Identified Aboriginal cultural assets and values

Please provide any comments you may have on the identified Aboriginal cultural assets and values on the floodplain.

Draft Billabong Creek Floodplain Management Plan

Figure 2. Proposed Floodway Network for the Billabong Creek floodplain

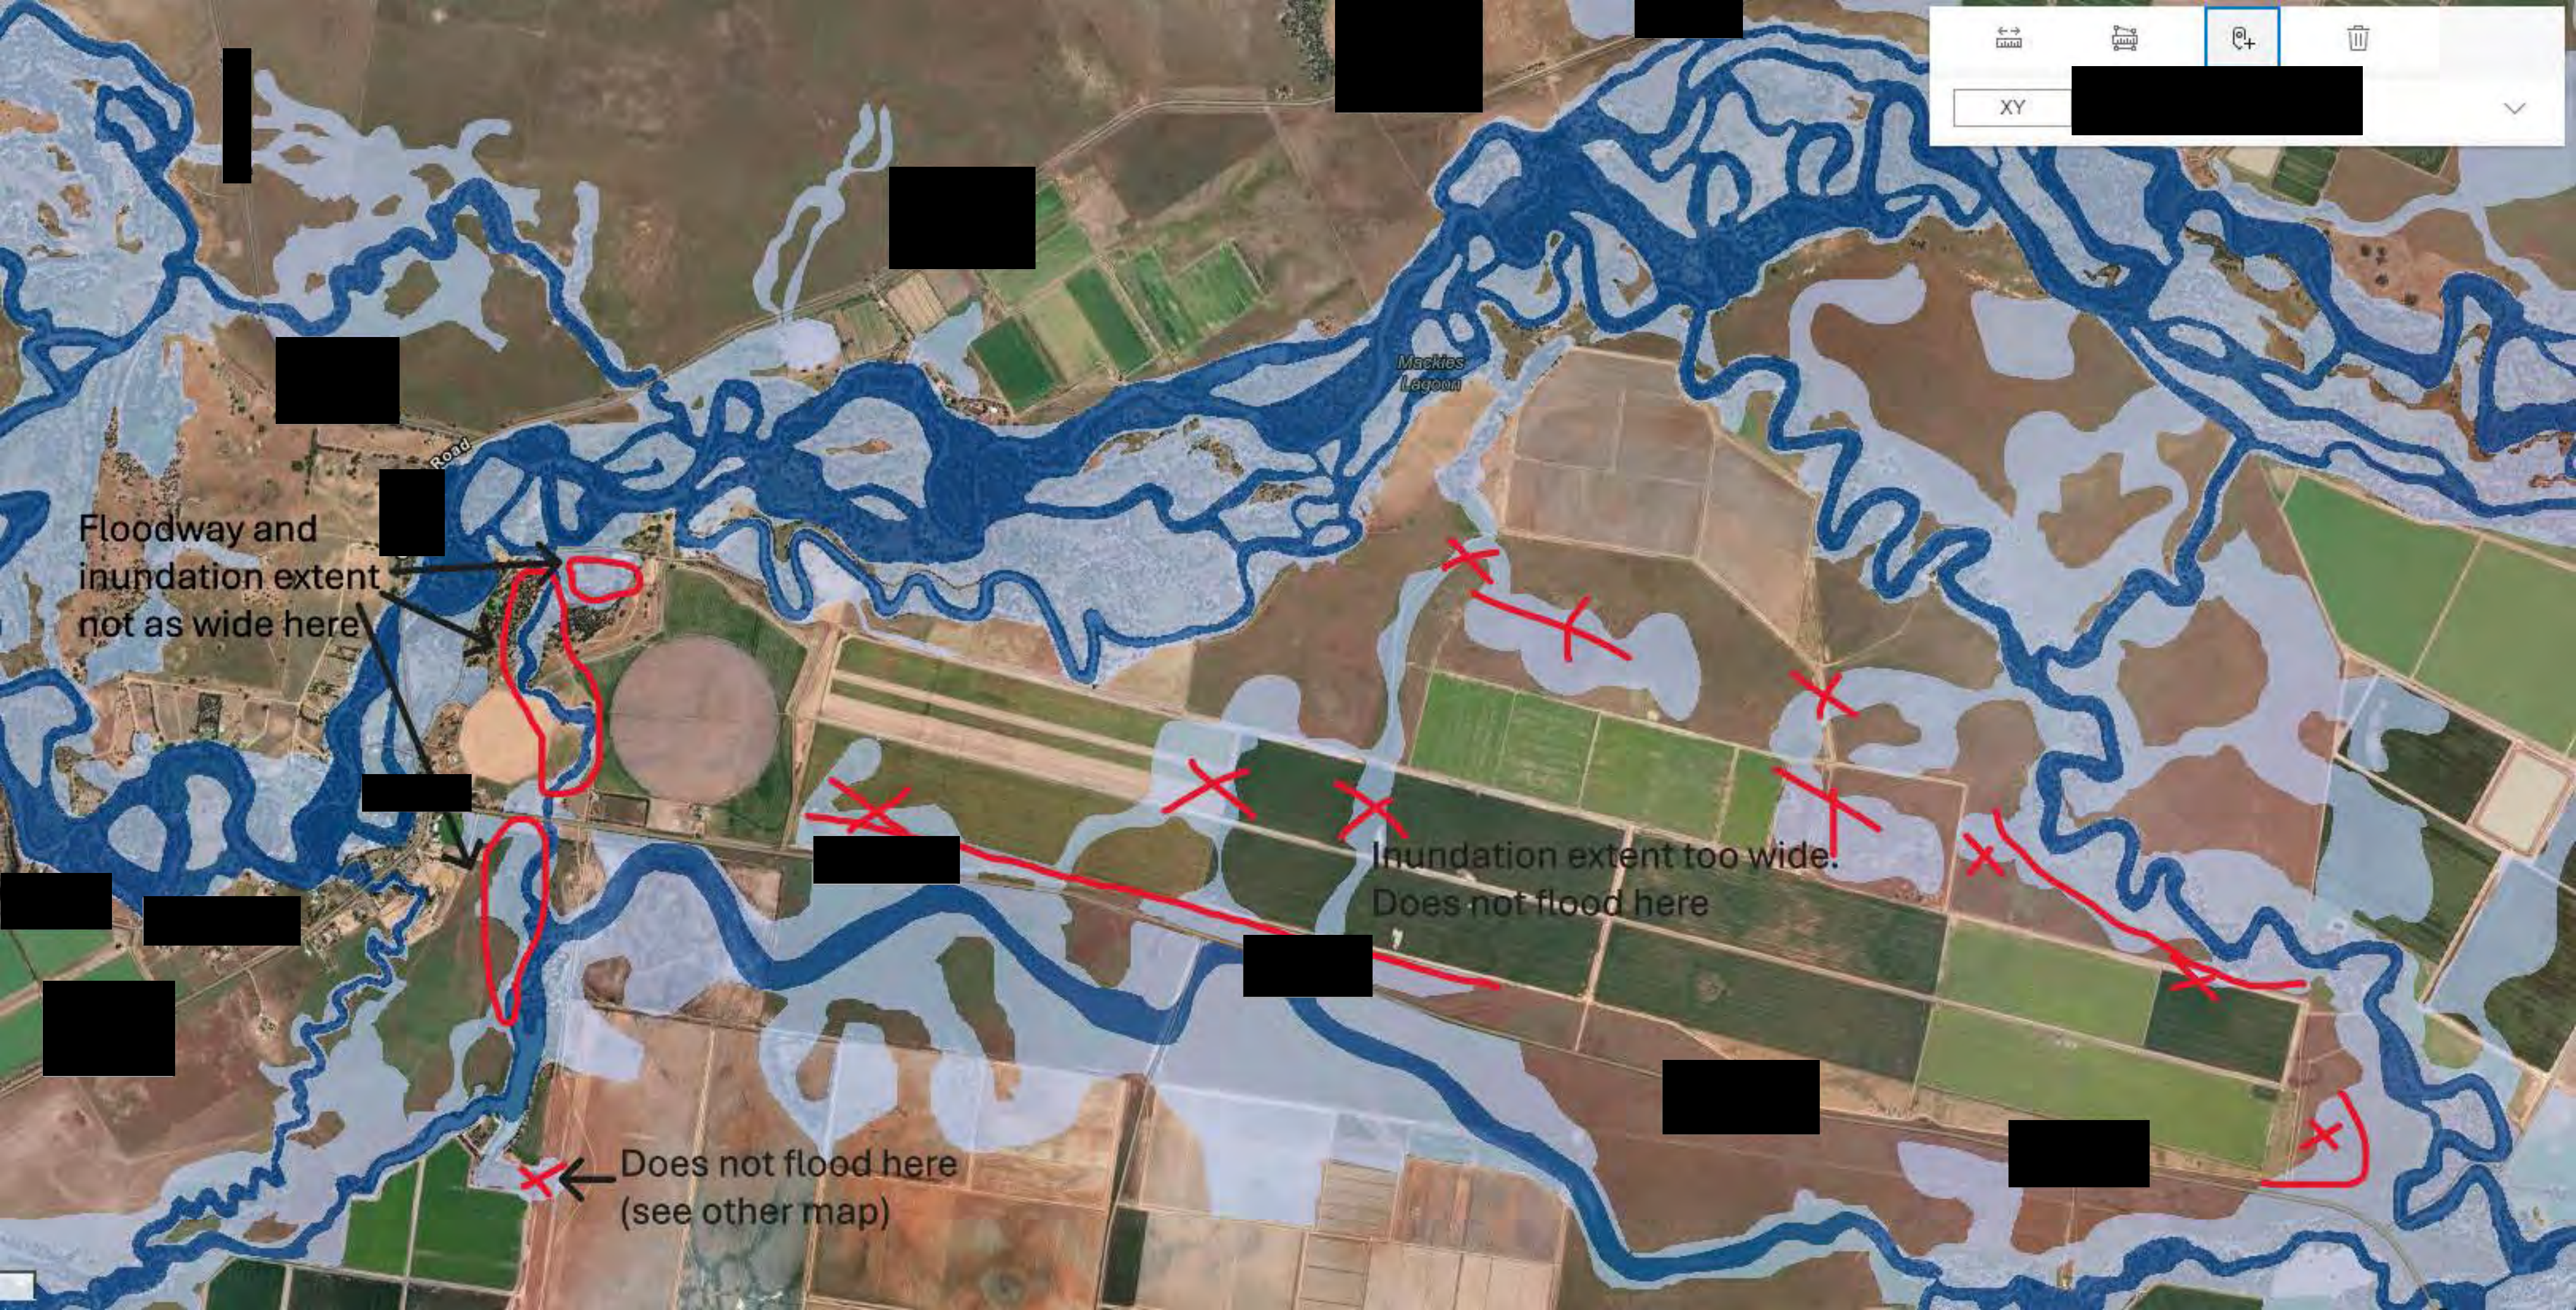
Vegetation mapping may need to be pared back along the edge of the already cleared area here

Pump site here is licensed. Vegetation mapping should be cleared away from the pump site.

Floodway and inundation extent not as wide here

Inundation extent too wide. Does not flood here

Does not flood here (see other map)

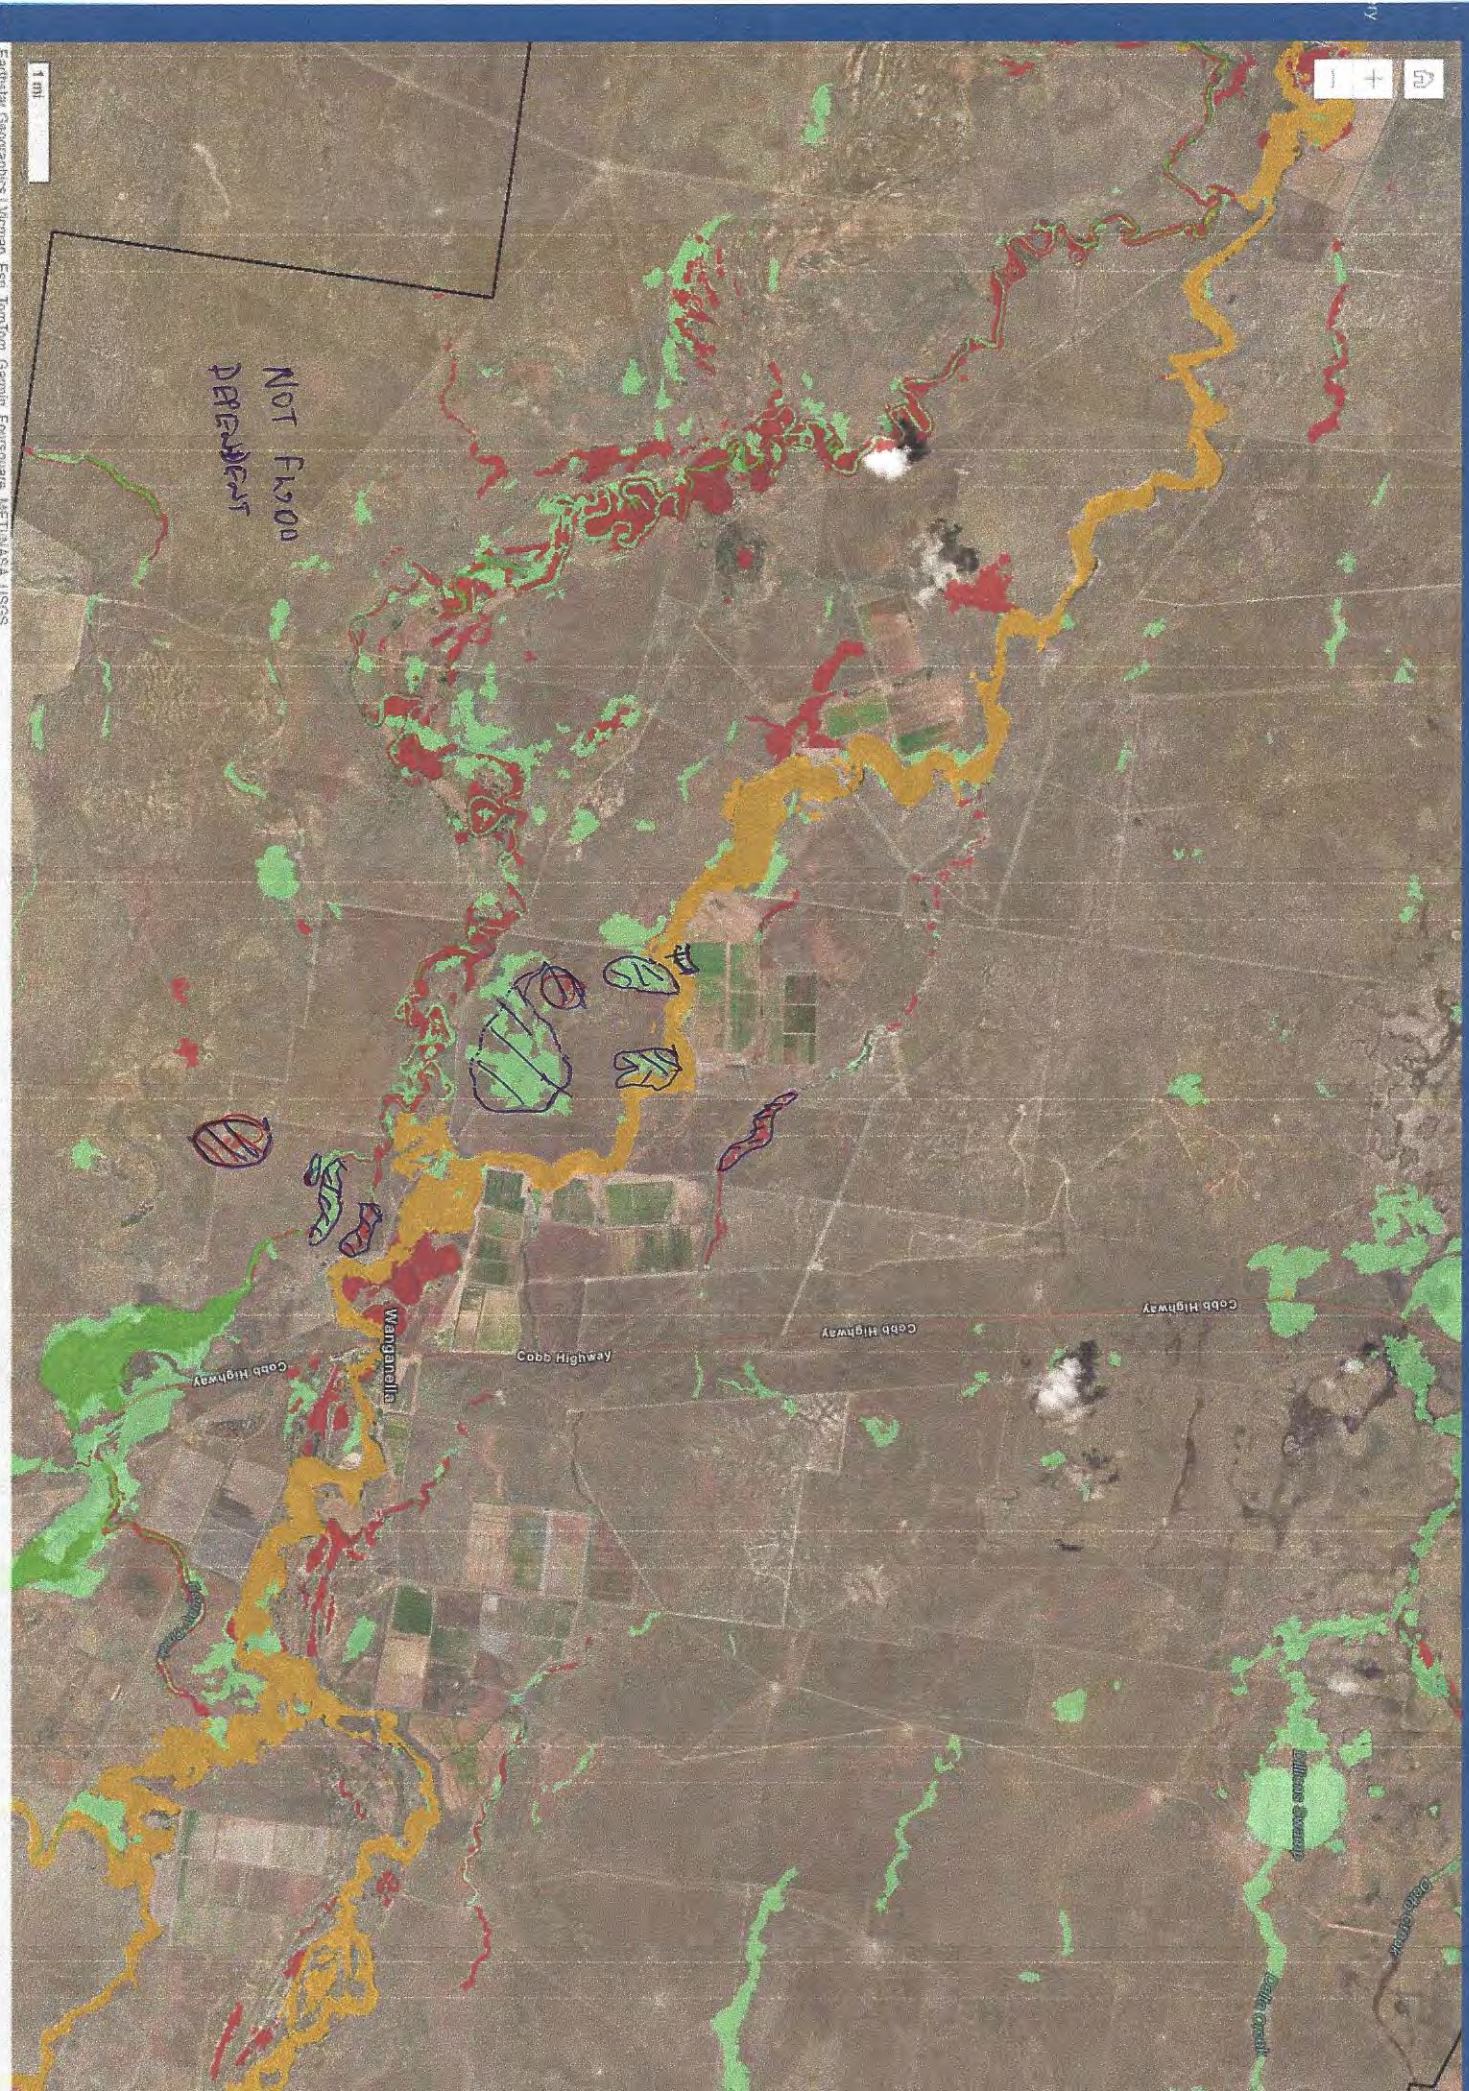
Sandhills/high ground
Not flood-dependent
vegetation

Vegetation around
the [redacted] is not
flood-dependent

Map 2.

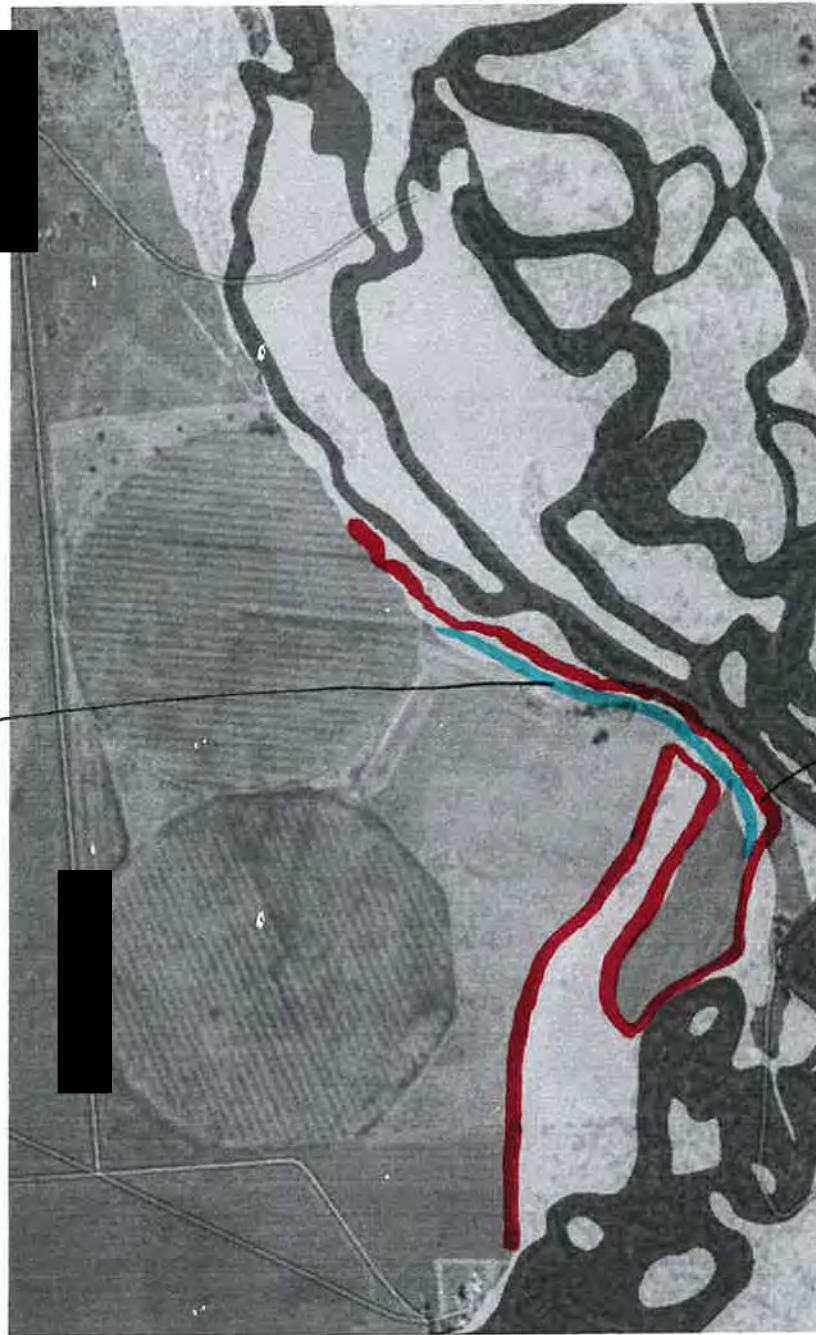
Aqua is a
farm track
that wasn't
flooded.

→ New
Boundary
for flood
water.

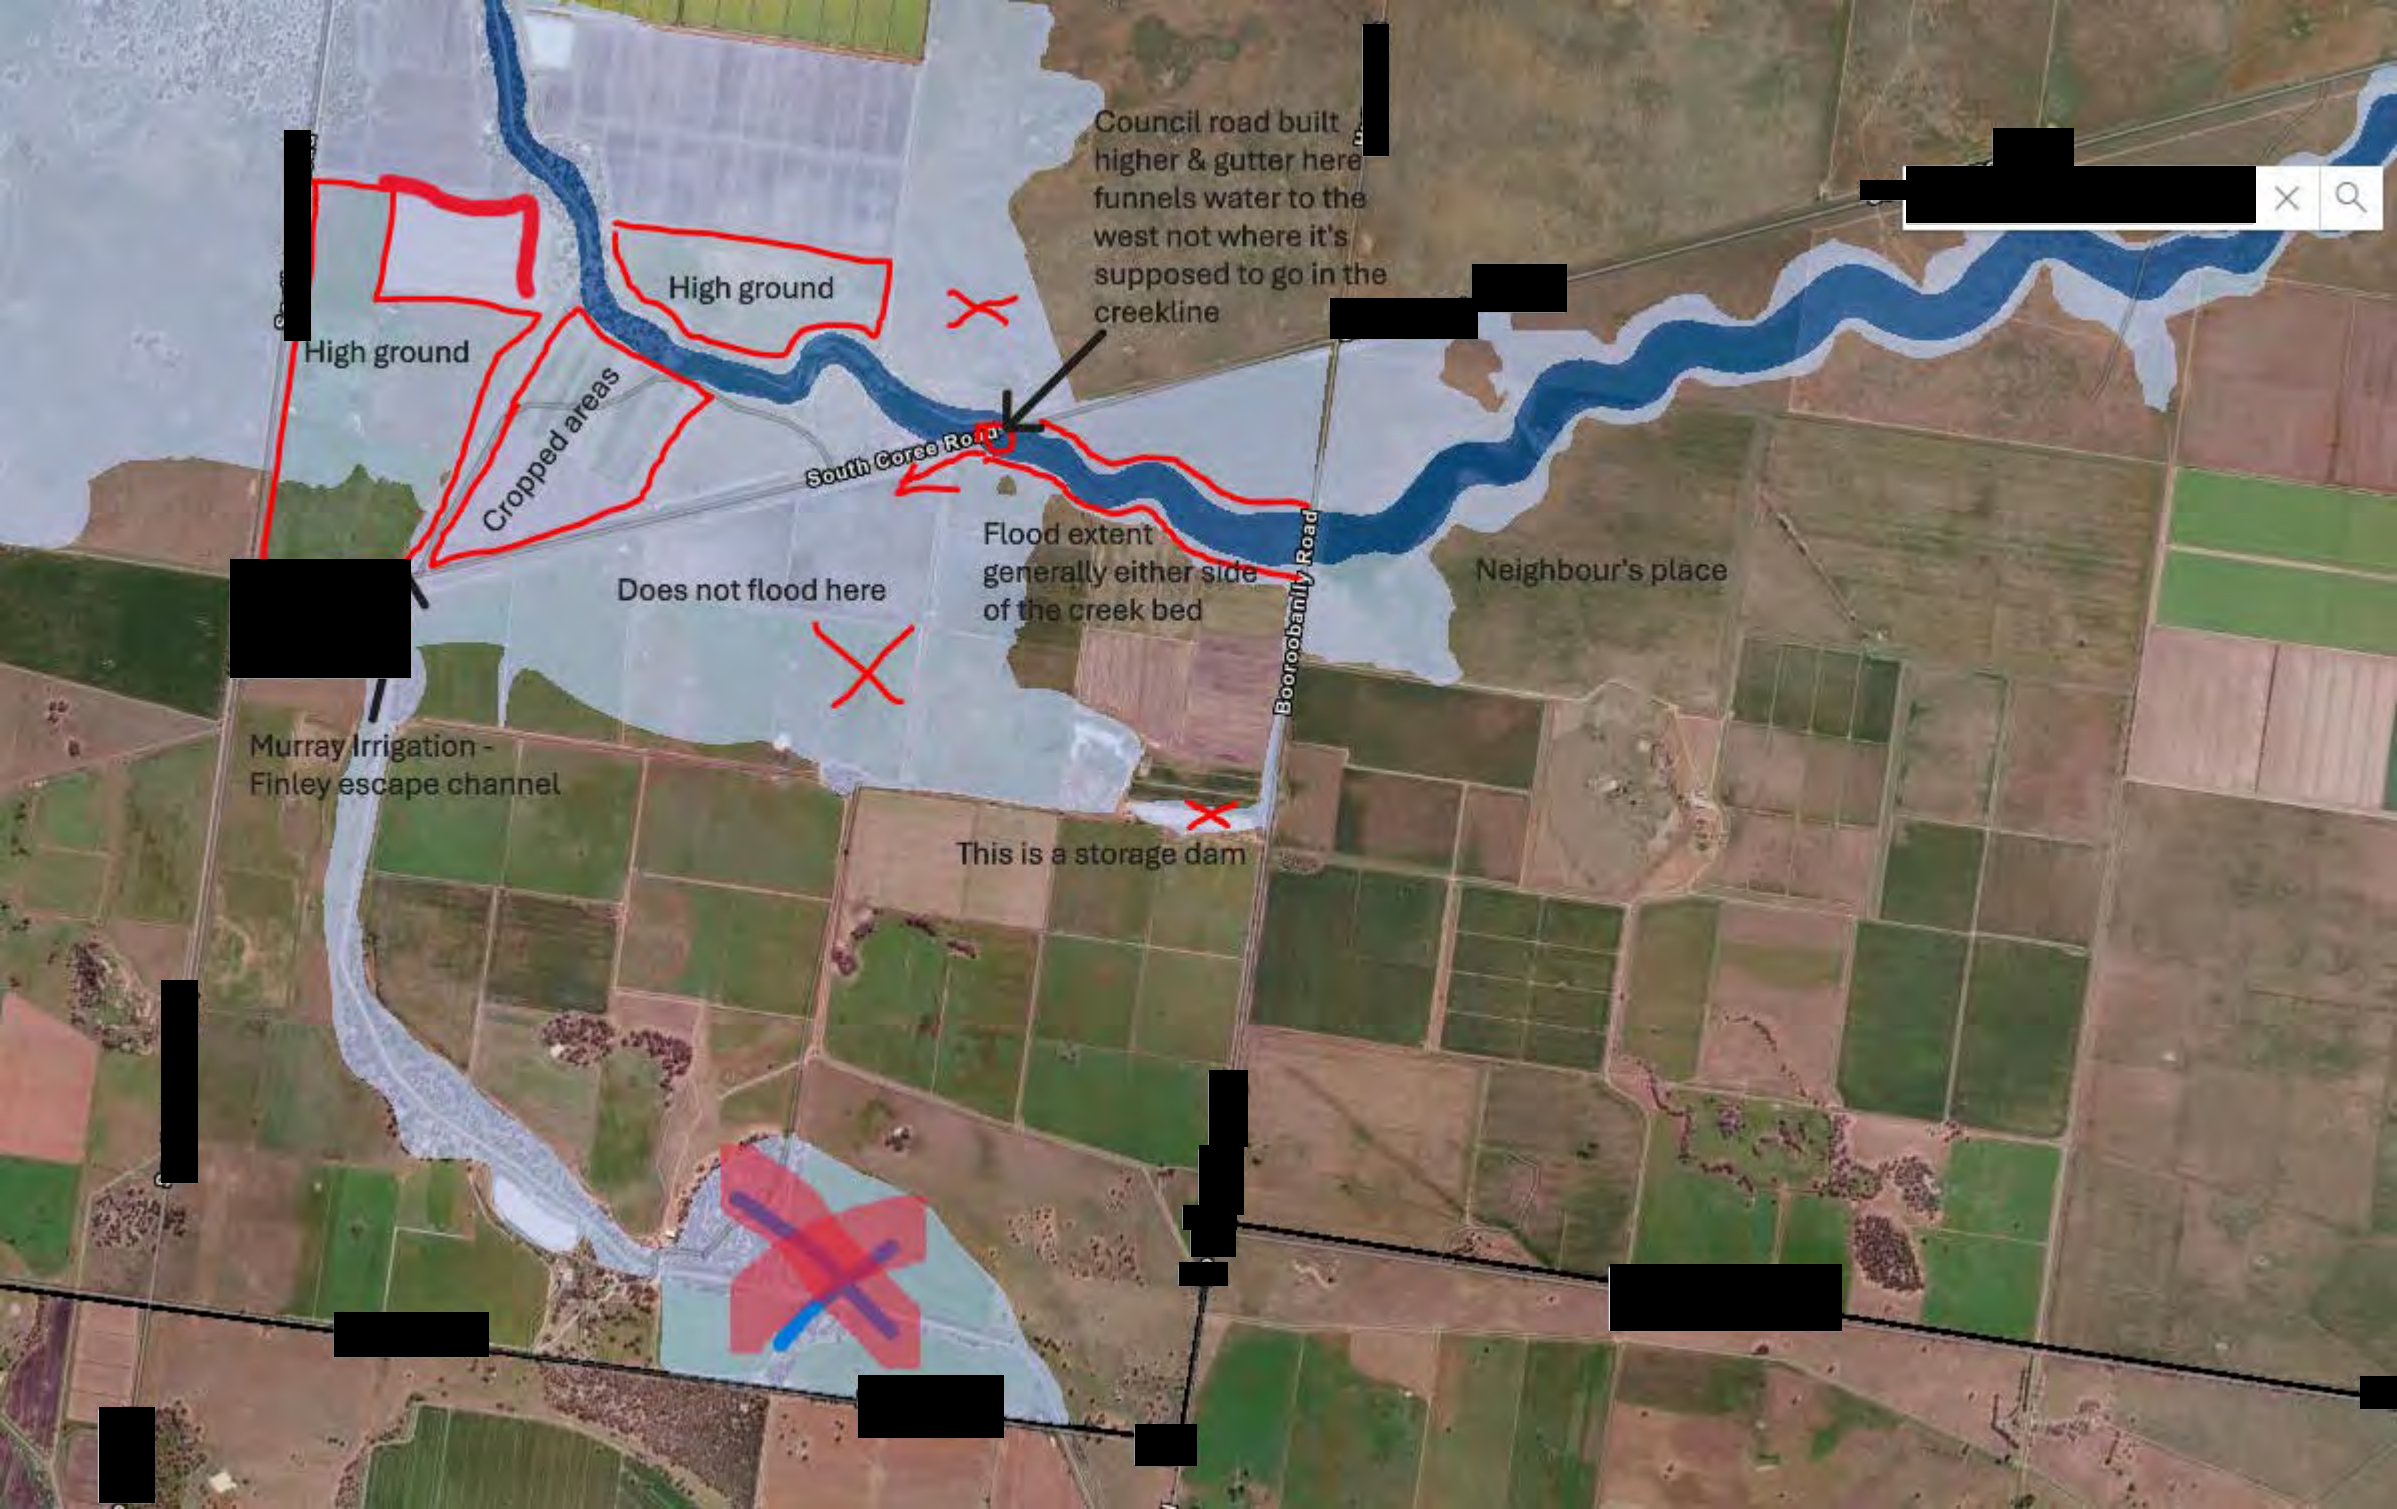
Council road built higher & gutter here funnels water to the west not where it's supposed to go in the creekline
